IEEE WG Revision C37.011 Application Guide for TRV for High-Voltage Circuit Breakers

Agenda of WG meeting in Orlando/Lake Buena Vista, May 18th 2011

Discussion of Comments on D7

Comment # 76

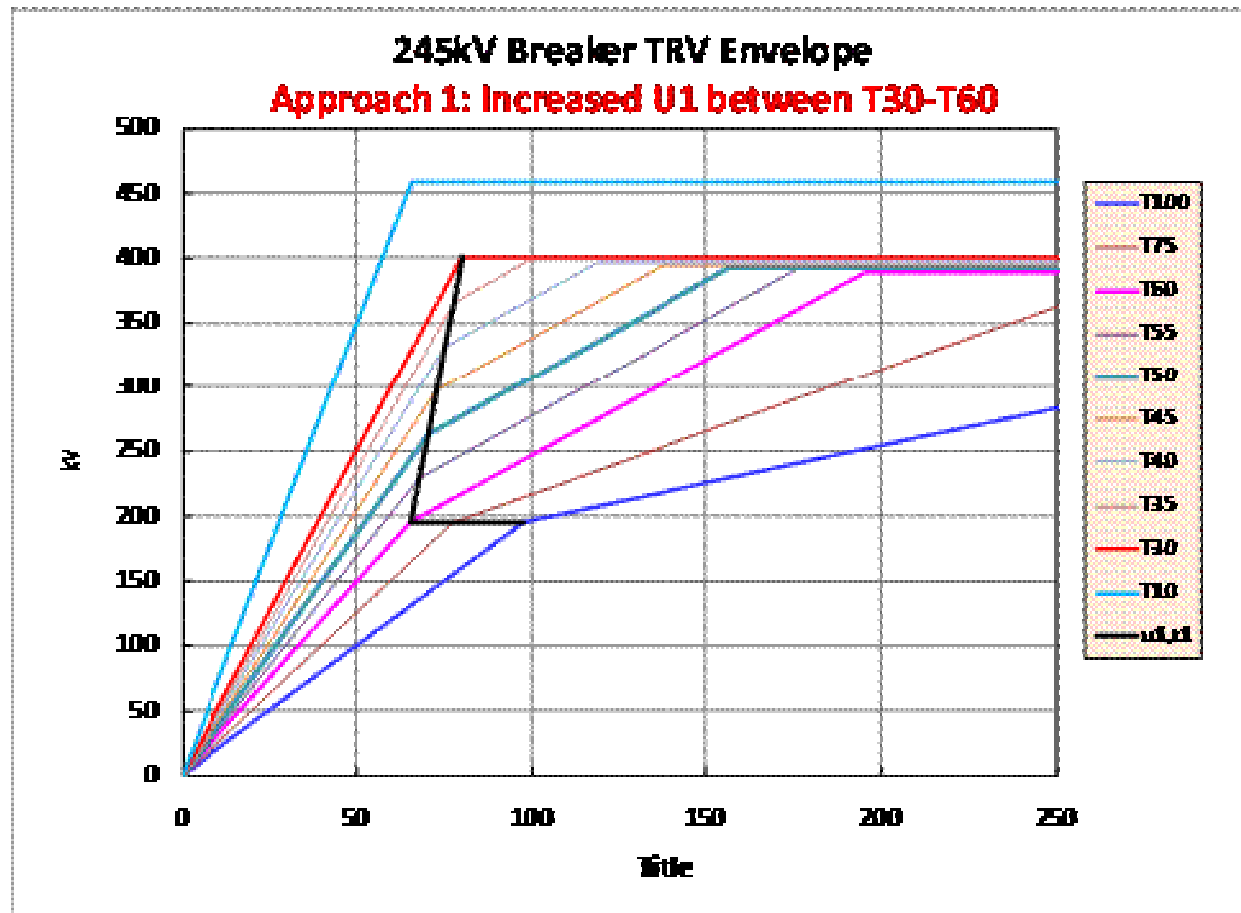
▶ Subclause 4.2

- ◆ This subclause talks about Circuit breaker capability. it is assumed to be the required TRV as defined by the system. This is understood and technically sound for the interpolation between T10 and T30 as well as for the interpolation between T60 and T100. However the transition from 2 parameter (T30) to 4 parameter (T60) is not understood. It is understood that the first freq. is defined by a transformer, inductance close to the breaker while the second freq. is given by the traveling wave. In this case the peak voltage of the first frequency (u_1) should be always in the same order of magnitude, while the time to U_c may change

- ◆ Develop a more technical sound method to interpolate between T30 and T60.

- ◆ **Two methods to interpolate TRVs between T30 and T60, selected during the meeting in Las Vegas (see next slide)**
 - **Approach 1 as defined in the present draft (u1 is interpolated between u1 of T60 and uc of T30)**
 - **Approach 2 as discussed in Las Vegas, with u1 constant between T30 and T60**
- ◆ **Discussion done by WG in November-December 2010 and April-May 2011**

► Approach 2

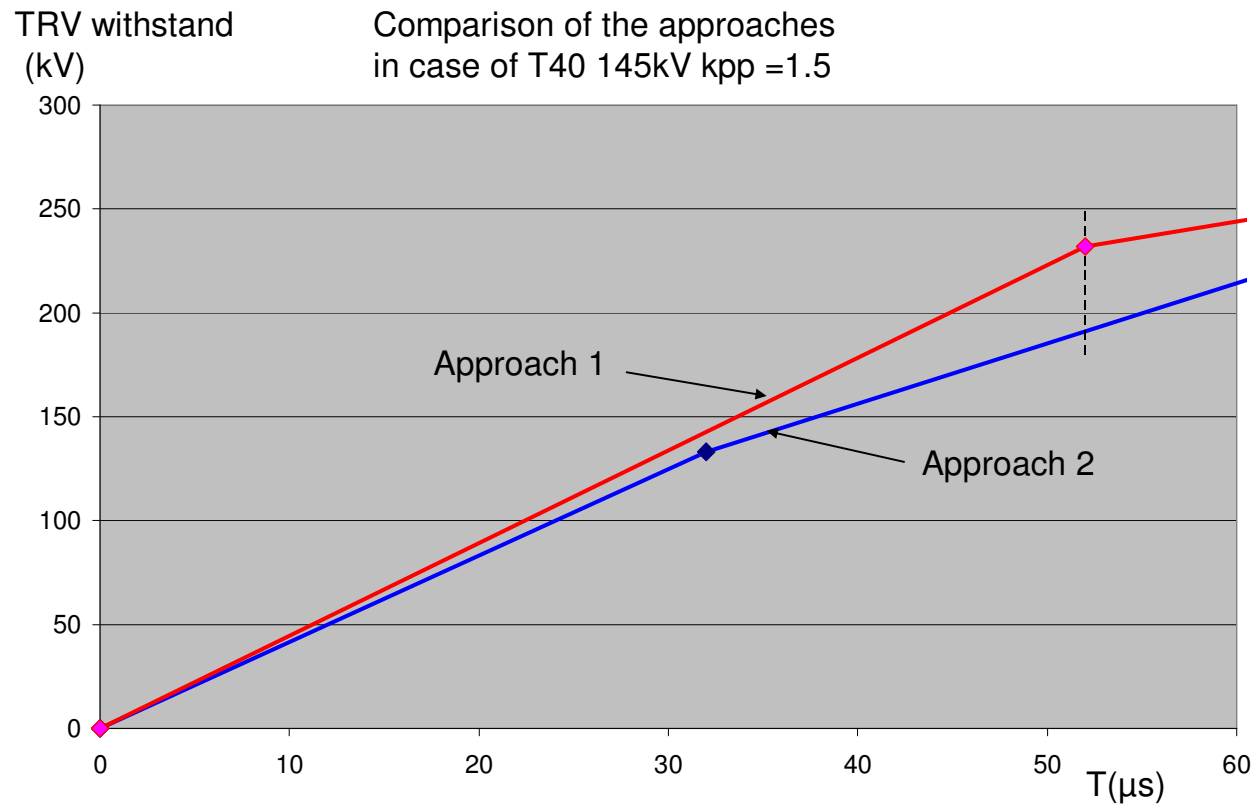
- ▶ What is the issue?
- ▶ It is the TRV withstand by a circuit breaker that can be expected after current zero until a time up to (approximately) t_3 for T30.

Comparison of the approaches
in case of T40 145kV kpp = 1.5

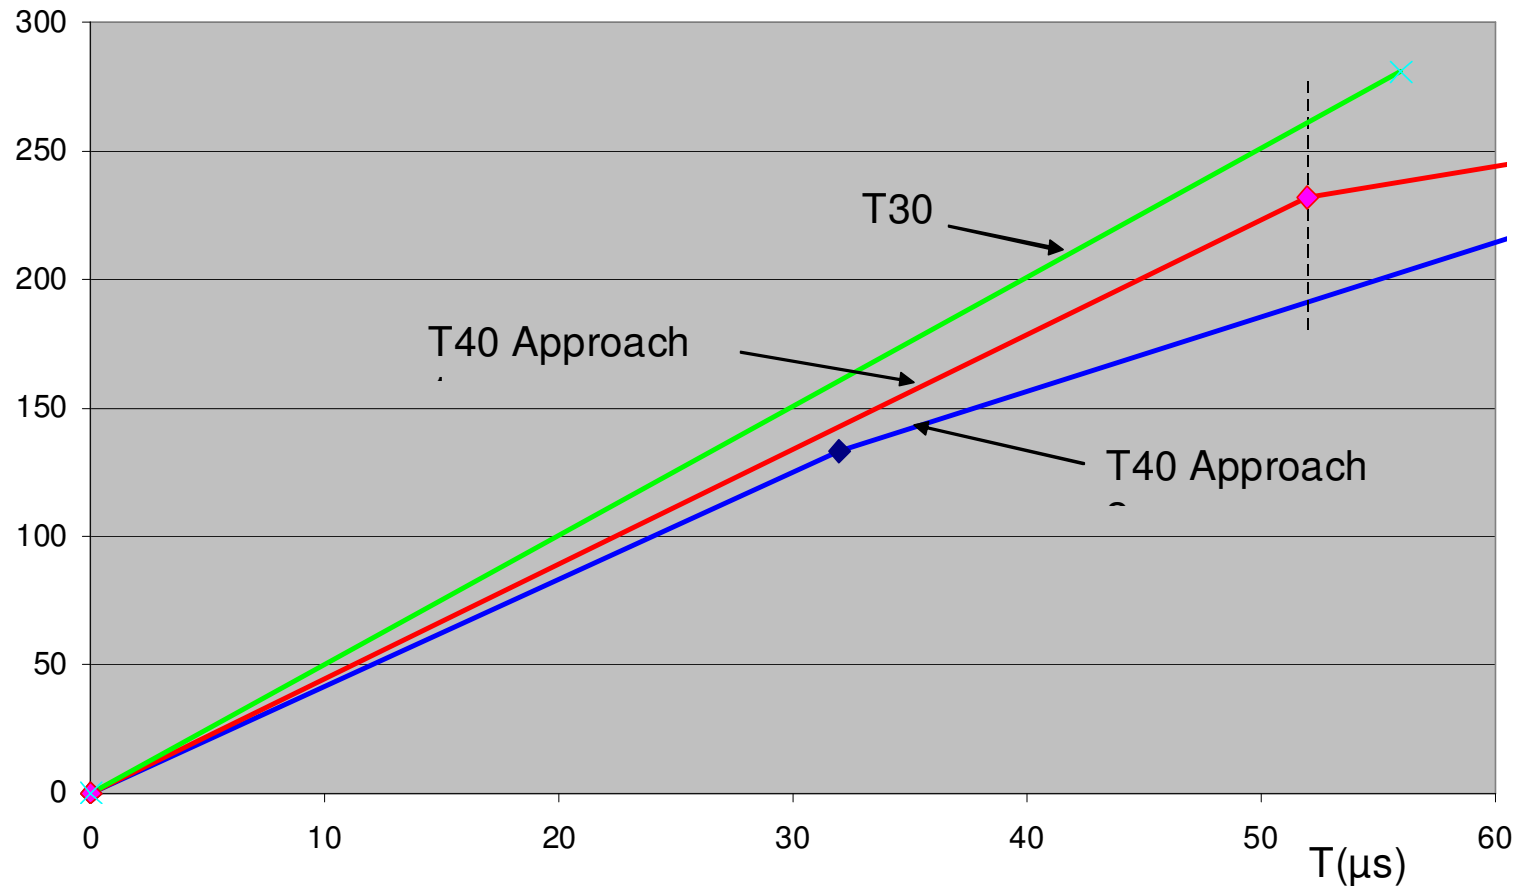
- ▶ Comparison of the TRV for T30 and the two approaches for T40

- ◆ **17 in favour to keep the approach 1 of Draft 7**
- ◆ 1 in favour to adopt approach 2 with a constant u_1 between T30 and T60
- ◆ 1 abstention

Approach 1 will be kept in the next draft.
